2016 Corvette: Service Bulletin: Delayed Engagement After Sitting With Engine Off

#16-NA-014: Delayed Engagement After Sitting With Engine Off - (Jan 21, 2016)

Subject: Delayed Engagement After Sitting With Engine Off

- (A) Old stator support asm 242
74636/24275106/2427265
6
- (B) New stator support asm
24277234

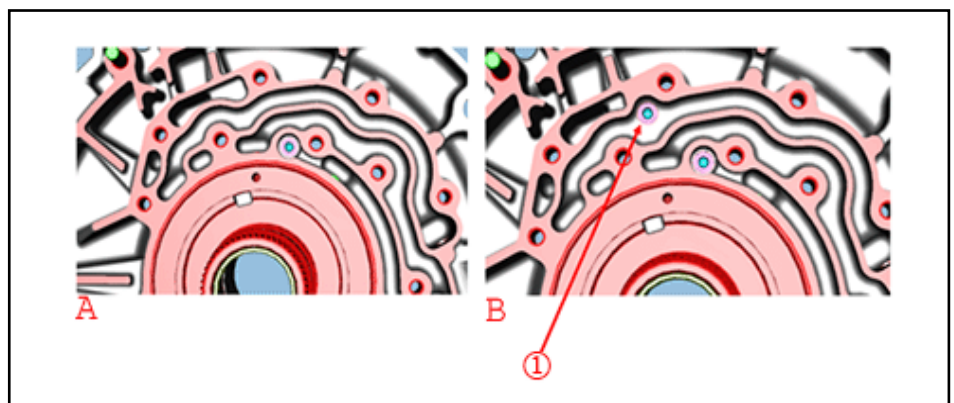
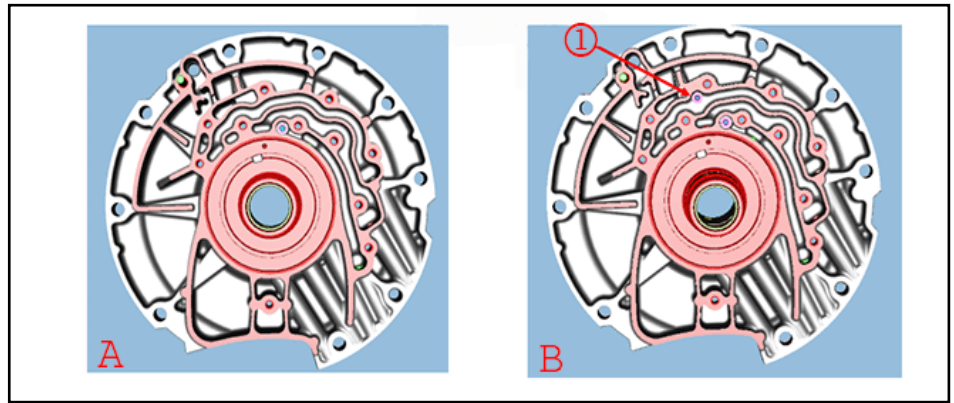
Note: The new stator shaft support assembly has a second check ball (1) added (see illustrations).

Install a new stator shaft support assembly that includes an additional check ball. Follow the instructions below to replace the stator shaft support assembly.

New cover 24277964

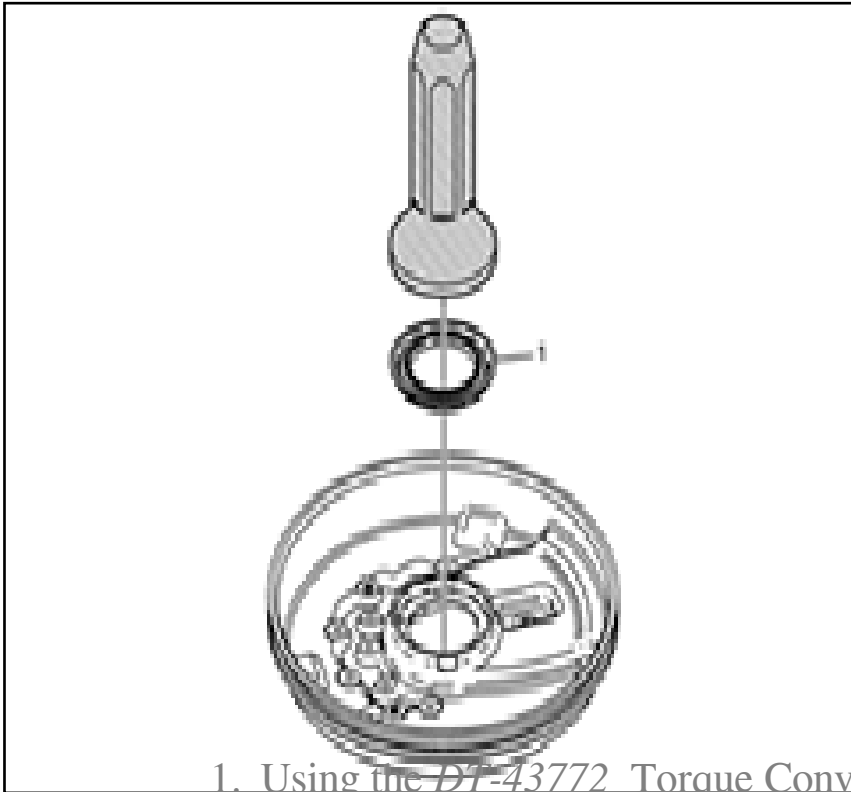
Note: The casting void has been eliminated from the underside of the cover (see illustration).
